Well Name: POKER LAKE UNIT 26 BD Well Location: T25S / R30E / SEC 26 /

Well Number: 156H Type of Well: CONVENTIONAL GAS

**Sundry ID: 2873735**

Type of Submission: Notice of Intent Type of Action: APD Change

#### ACREAGE DEDICATION PLATS

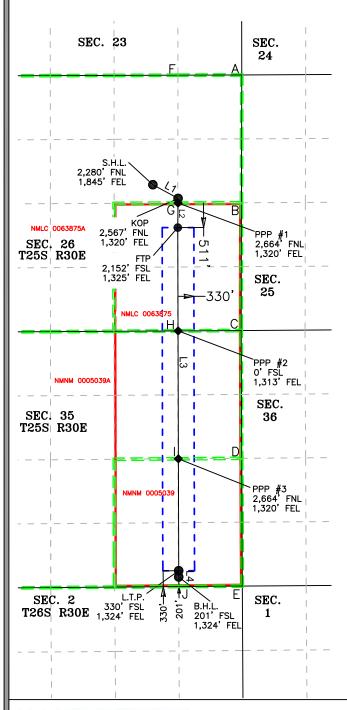
Procedure Description: Effective Date: 5/1/22 XTO Permian Operating LLC respectfully requests to make the following changes for well record clean up: Dedicated acres: f/240 t/480 FTP: f/ 1320' FEL & 2567' FNL t/ 2152' FSL & 1325' FEL, Sec 26-25S-30E; Lease NMLC0063875 BLM previously approved sundry Id #2662536. Attachments: Updated C-102 on new required form. No new surface disturbance.

# WELL LOCATION AND ACREAGE DEDICATION PLAT

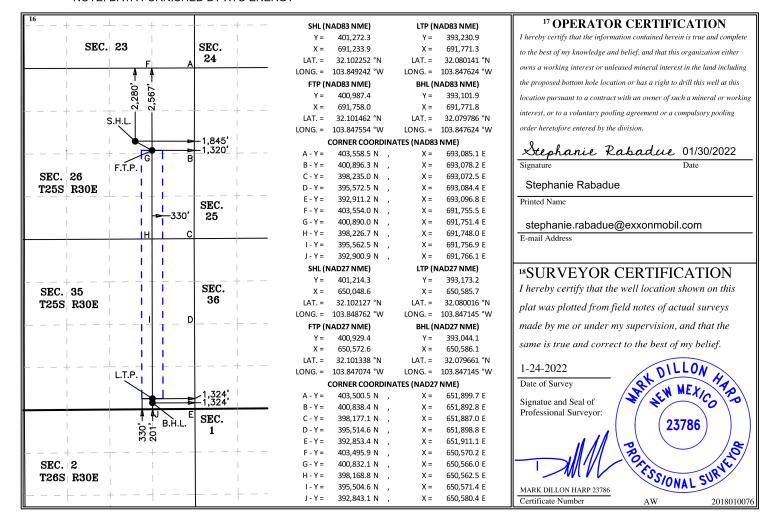
Procedure Description: \*\*Pool Change, Spacing, Casing/Cement, Drilling Variance Changes XTO Permian Operating, LLC requests permission to make the following changes to the original APD: Change Pool from: Purple Sage; Wolfcamp (Gas) to Wildcat; Bone Spring No Additional Surface Disturbance Change BHL fr/200'FSL & 1650'FEL to 201'FSL & 1324'FEL, Section 35-T25S-R30E Casing/Cement design per the attached drilling program. Attachments: C102 Drilling Program Directional Plan Multibowl Diagram
